1 ELECTRICAL PLAN

City of Homer
DWD UPLANDS

Drawn By: CF
Checked By: CF
Date: JANUARY 22, 2016
Phase: BID DOCUMENTS
Project No: 1841.05
SHEET TITLE: ELECTRICAL PLAN
SHEET NO: 26 OF 34
E1.2

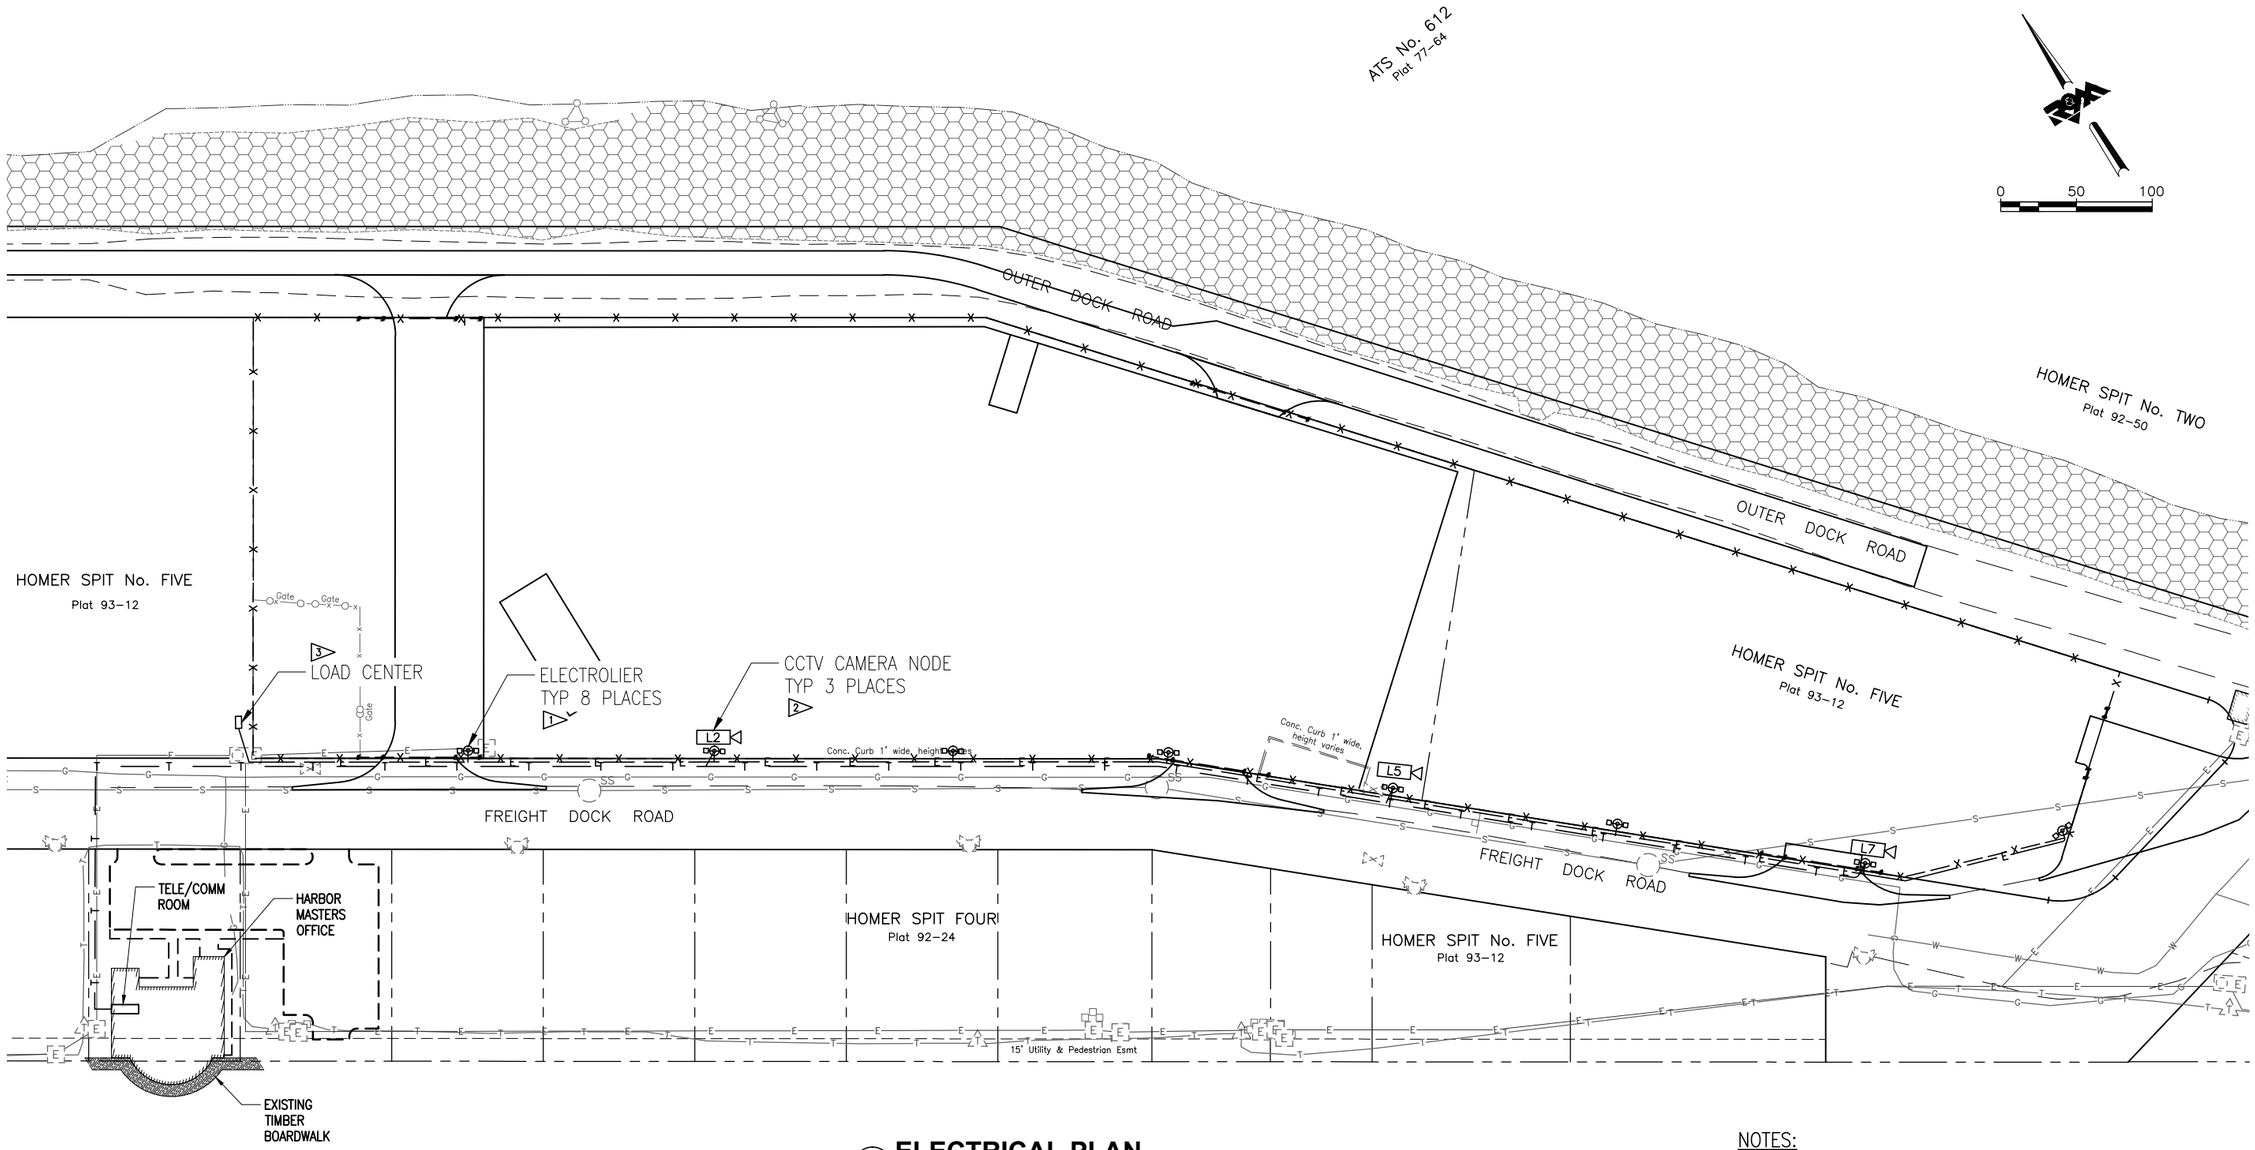
1 REVISION 1; PREVIOUS VERSIONS OF THIS DRAWING SHALL NOT BE USED; DRAWING REVISED TO MOVE ELECTROLIERS FROM NORTH SIDE OF PROPERTY TO SOUTH SIDE OF PROPERTY; REDUCE NUMBER OF ELECTROLIERS FROM 9 TO 8; RENUMBER ELECTROLIERS, L1 TO L8, FROM LEFT TO RIGHT; RELOCATE CCTV CAMERA NODES, RENUMBER CCTV CAMERA NODES TO CORRESPOND WITH RENUMBERED ELECTROLIERS; THIS RENUMBERING OF ELECTROLIERS HAS IMPLICATIONS THROUGHOUT THE ELECTRICAL DESIGN PACKAGE, COORDINATE AND RED LINE DESIGNATORS ACCORDINGLY WHERE ENCOUNTERED IN THE DUE COURSE OF WORK.
